Natoma St Extension

<div>17/9/18 PCO #8 Natoma Extension</div> <div>NO. DATE DESCRIPTION BY APP.</div> <div>TABLE OF REVISIONS</div>		<div>REFERENCE INFORMATION & FILE NO. OF SURVEYS</div>		<div>SAN FRANCISCO PUBLIC WORKS</div> <div>BUREAU OF DESIGN & ENGINEERING</div> <div>CITY & COUNTY OF SAN FRANCISCO</div> <div>SAN FRANCISCO PUBLIC WORKS</div> <div>30 VAN NESS AVENUE, 5TH FLOOR</div> <div>SAN FRANCISCO, CA 94102 - 6028</div>	<div>Section Mgr: PHILIP THWIN</div> <div>Deputy Bureau Mgr: IQBALBHAI DHAPA</div> <div>Bureau Mgr: PATRICK RIVERA</div>	<div>DESIGNED: ST/RN 9/18</div> <div>DRAWN: ST 9/18</div> <div>CHECKED: SL/RN 9/18</div>		<div>SCALE: 1" = 5'-0"</div> <div>SHEET OF SHEETS</div>	<div>2ND STREET STREETSCAPE IMPROVEMENTS PROJECT</div> <div>STREET LIGHTING PLAN</div> <div>NATOMA STREET, 2ND ST TO TRANSBAY TERMINAL</div>	<div>CONTRACT NO. 1064J</div> <div>DRAWING NO. NE-1</div> <div>FILE NO. 106,287.1</div> <div>REV. NO. 1</div>

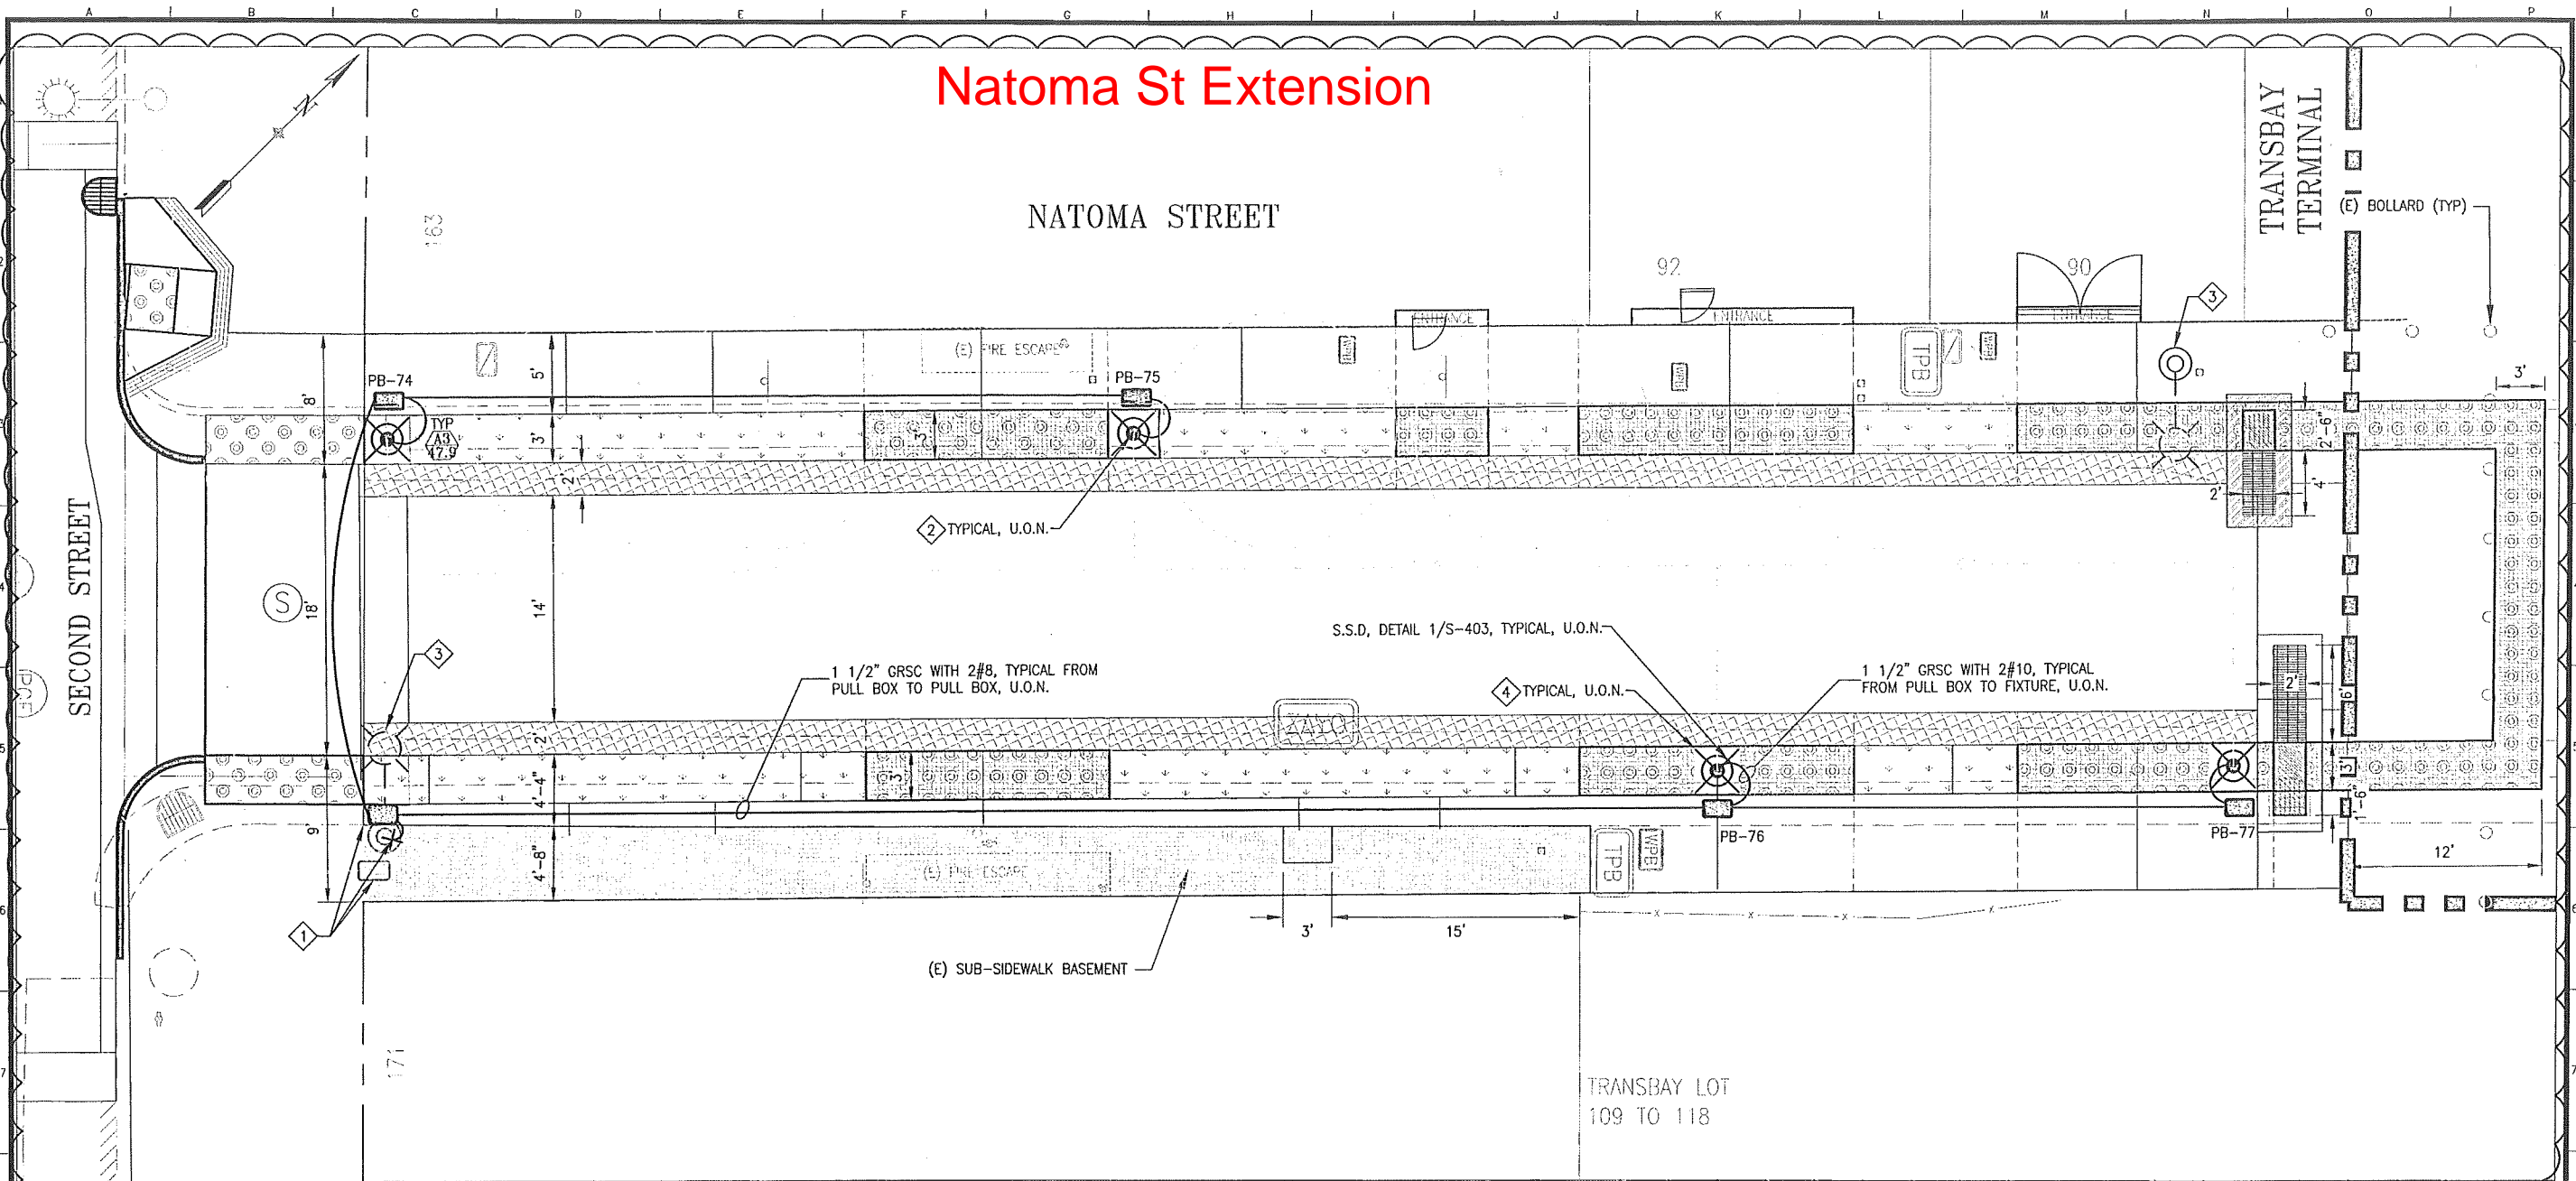
- 1 INTERCEPT EXISTING STREETLIGHT CONDUIT WITH A TYPE I PULL BOX ON SIDEWALK SURFACE. SPLICE NEW WIRES AND EXISTING WIRES IN EXISTING SUB-SIDEWALK BASEMENT PULL BOX.
- 2 PROVIDE 10A FUSE AND FUSE HOLDER FOR NEW PEDESTRIAN LIGHTS.
- 3 R/C STREET LIGHT POLE, ARM AND FIXTURE.

E-10 (pullbox) = (2)
E-13 (1.5" conduit) = 65ft
